Submission to Preferred Project Report for Proposed  
Mixed Use Redevelopment

by Leichhardt Council

Balmain Leagues Club Precinct

Job No: 9071af  
December 2012  
© Willana Associates Pty Ltd 2012  
ABN 93 868692799

Figure 1: Extract of Figure 4.29 of the draft NSW Transport Master Plan indicating minimum, average and maximum AM peak travel speeds on key roads in Sydney.

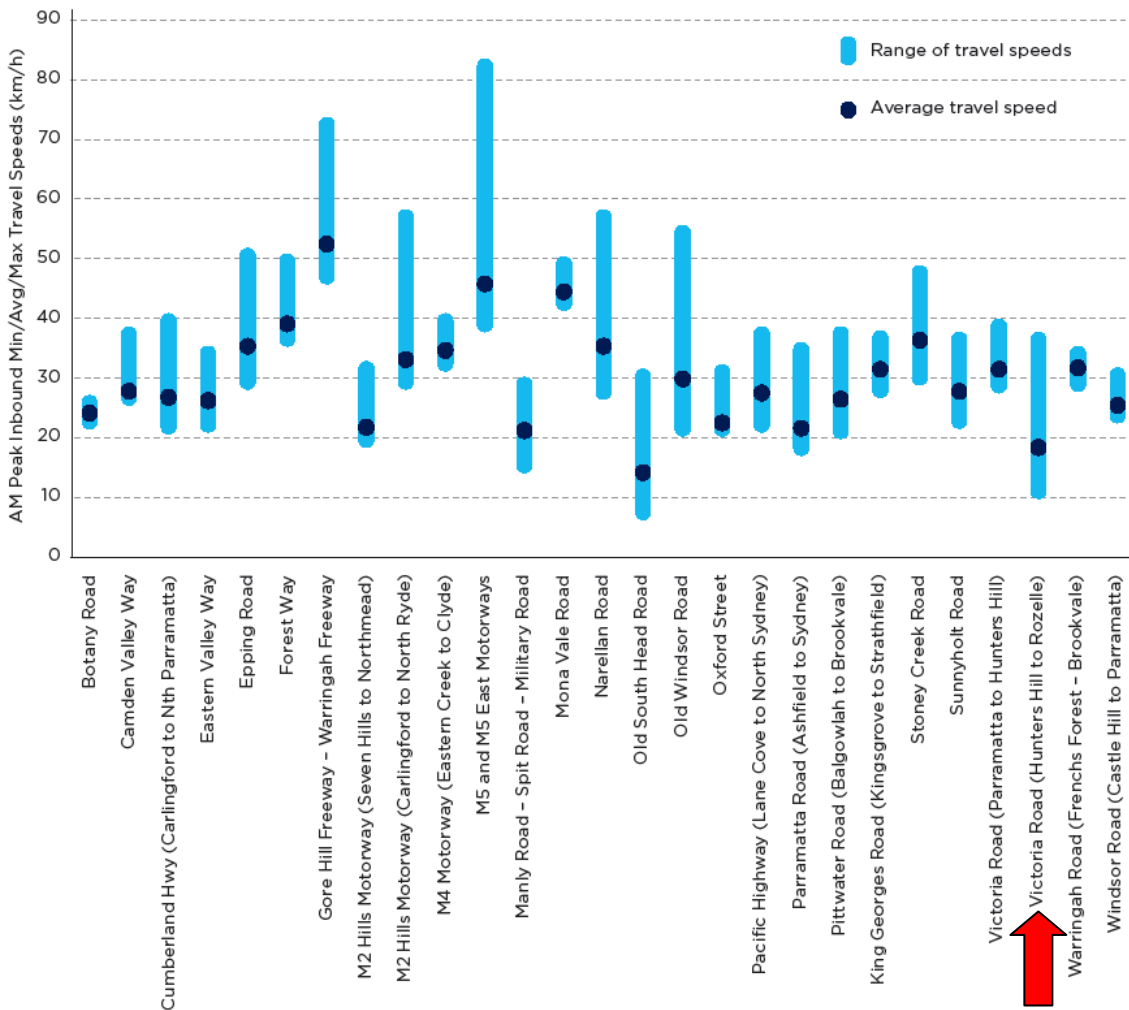
Furthermore, the NSW Auditor-General's Report - Volume Eight 2012 – Focus on Transport and Ports, released on the 5 December 2012 has identified on p19 that Victoria Road has the slowest average travel speeds in both the morning and afternoon peak periods of all of the seven major routes to and from Sydney.
